Revised First Work Plan for Characterization and Off-Site Disposal of South and East  
Crushed Concrete Piles and West Pad  
Trinity Superfund Site  
Cleveland, Ohio

**First Work Plan for  
Characterization and Off-Site  
Disposal of South and East  
Crushed Concrete Piles and West  
Pad**

Trinity Superfund Site  
Cleveland, Ohio

June 2008  
Revised July 2008

FIGURE  
3

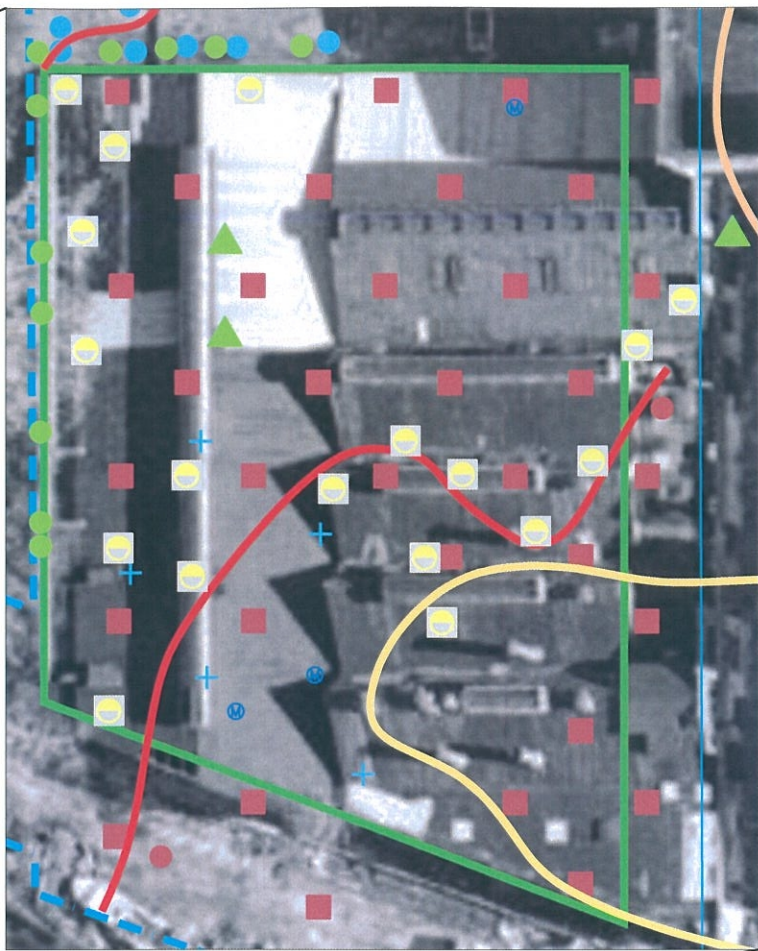
The 50 ppm line shall be extended north to include the 10,000 ppm and 5,600 ppm PCB concentrations previously identified and as the USEPA has marked in the field. We have updated Figure 3 to show the approximate location of this line. We understand the actual line is as the USEPA has marked it in the field. West Pad sample locations are depicted on Figures.
